DEVELOPMENT NO:	24024973
APPLICANT:	Eastern Building Group c/- Future Urban
AGENDA ITEM NO:	3.1
ADDRESS:	18 - 20 Walter Street, North Adelaide SA 5006
NATURE OF DEVELOPMENT:	Construction of a nine level residential flat building
ZONING INFORMATION:	<p>Zones:</p> <ul style="list-style-type: none"> • City Main Street <p>Subzones:</p> <ul style="list-style-type: none"> • City High Street <p>Overlays:</p> <ul style="list-style-type: none"> • Aircraft Noise Exposure • Airport Building Heights (Regulated) • Affordable Housing • Building Near Airfields • Design • Hazards (Flooding - Evidence Required) • Noise and Air Emissions • Prescribed Wells Area • Regulated and Significant Tree <p>Technical Numeric Variations (TNVs):</p> <ul style="list-style-type: none"> • Maximum Building Height (22 Metres) • Maximum Building Height (6 Levels)
LODGEMENT DATE:	30 August 2024
RELEVANT AUTHORITY:	City of Adelaide Council Assessment Panel

PLANNING & DESIGN CODE VERSION:	Version 2024.16 – Consolidated 29 August 2024
CATEGORY OF DEVELOPMENT:	Code Assessed – Performance Assessed
NOTIFICATION:	Yes
RECOMMENDING OFFICER:	PC
REFERRALS STATUTORY:	Environment Protection Authority Minister responsible for the a

Figure 2.1 – Lodged and Amended Proposal Comparisons

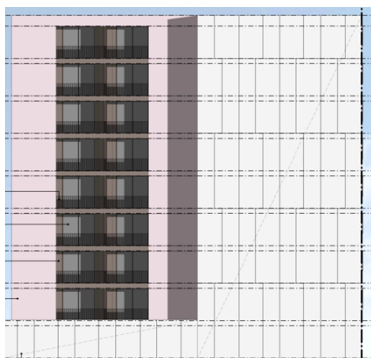
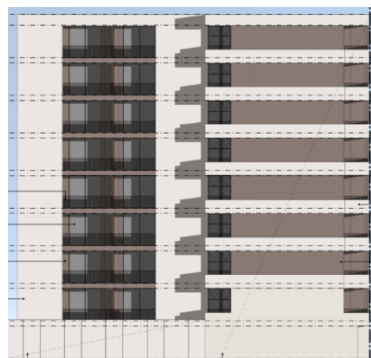
Administration held on-going discussions with the applicant regarding the proposed height and design quality throughout the assessment process. Initially, the applicant was advised the proposal could not be supported as the design was not of sufficient quality and the relationship with adjacent lower scale development had not been adequately addressed. Amendments were made to the overall design, prior to public notification being undertaken.

During public notification, issues regarding design quality (amongst other matters) were also raised by representors. Once public notification had concluded, Council Administration reiterated concerns with the design quality. The applicant responded with an amended design which is the subject of this report. Comparisons between the lodged design and amended design are demonstrated in Figure 2.1.
